ramię (2 połówki) Makita
183L76-5 (nowy numer
183T15-3)

DC179

Title	Change of Arm set, Joint, Hose connector, Dust nozzle Elimination of O ring 20, O ring 23 Addition of Rivet 7
Model	DSL800, XLS01
Country	All countries
Description	To improve the dust collecting efficiency; • Arm set, Joint, Hose connector and Dust nozzle will be changed. • O ring 20 and O ring 23 will be eliminated. • Rivet 7 will be added.

[1] Arm set (183L76-5)

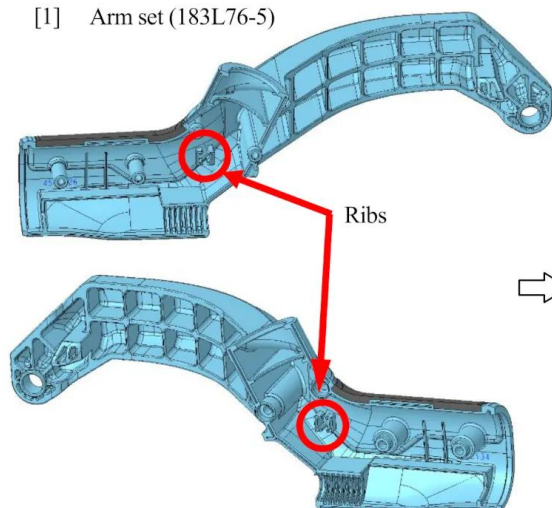
Arm set (183T15-3)

[2] Joint (459222-3)

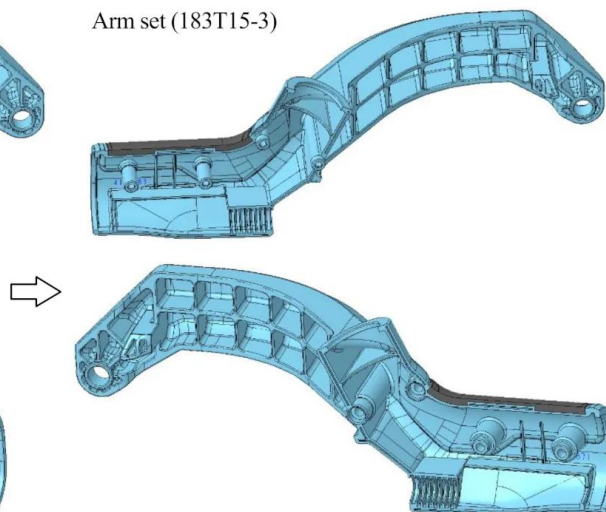
Joint (422617-3)

[3] Hose connector
(459223-1)

Hose connector
(413490-2)

- [4] Elimination of O ring 20 attached to the current Joint
- [5] Elimination of O ring 23 attached to the current Joint

[6] Dust nozzle (459234-6)

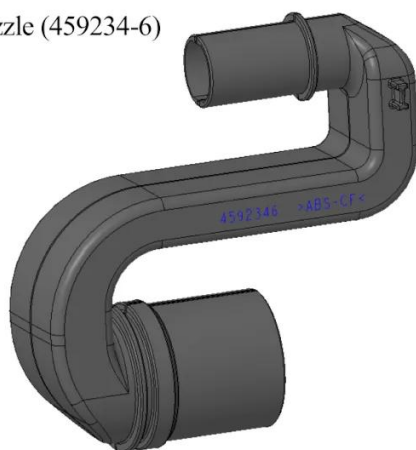
Dust nozzle assy (127672-7)
